# Access Compliance Report

## Public Rights-of-Way

### (Curb Ramps)

Intersection ID: 29684	Main Street: CAMERON_CREEK_DR	Cross Street: HAMPTON_GLEN_CT	Location: S
ADA ID: FE1AA78A6915	Ramp Type: PerpDiag	Initial Pass/Fail: Fail	Overall Compliance: No
Severity Score: 8.75			
Codes/Mitigation Info/Possible Solution		Field Measurements/Component Compliance

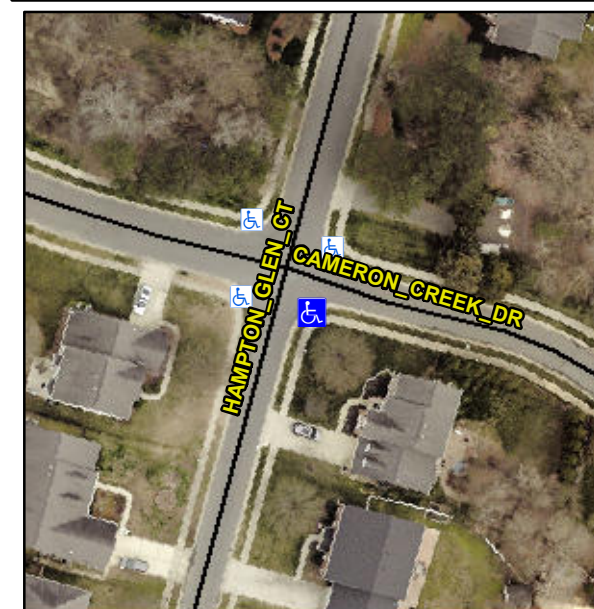
**Not Found, R304.5.1**

Compliance	Description	Data	Compliance	Description	Data
N/A	Ramp Length (in)	52.5	Yes	Ramp Slope (%)	5.6
No	Ramp Width (in)	44.0	Yes	Ramp XSlope (%)	0.2
N/A	Flare Type LT	N/A	N/A	Flare Type RT	N/A
N/A	Flare Slope LT (%)	N/A	N/A	Flare Slope RT (%)	N/A
N/A	Flare Traversable LT?	N/A	N/A	Flare Traversable RT?	N/A
N/A	Landing Length (in)	N/A	N/A	DWS Provided?	N/A
N/A	Landing Width (in)	N/A	N/A	DWS Contrast?	N/A
N/A	Landing Slope (%)	N/A	N/A	DWS Length (in)	N/A
N/A	Landing X Slope (%)	N/A	N/A	DWS Full Width?	N/A
N/A	Landing Curb? (Y/N)	N/A	N/A	DWS Offset (in)	N/A
N/A	Shared Landing?	N/A			
N/A	Gutter Ponding?	N/A	N/A	Gutter Slope (%)	N/A
N/A	Gutter Lip Ht (in)	N/A	N/A	Gutter X Slope (%)	N/A
N/A	Painted X Walk1?	No	N/A	Painted X Walk2?	No
	X Walk 1 Direction	To NE		X Walk 2 Direction	To NW
N/A	X Walk 1 Width (in)	N/A	N/A	X Walk 2 Width (in)	N/A
	X Walk 1 Slope (%)	2.2		X Walk 2 Slope (%)	3.2
	X Walk 1 X Slope (%)	2.8		X Walk 2 X Slope (%)	0.7

**Remove & Replace Curb Ramp With Two New Directional Ramps or Equivalent.**
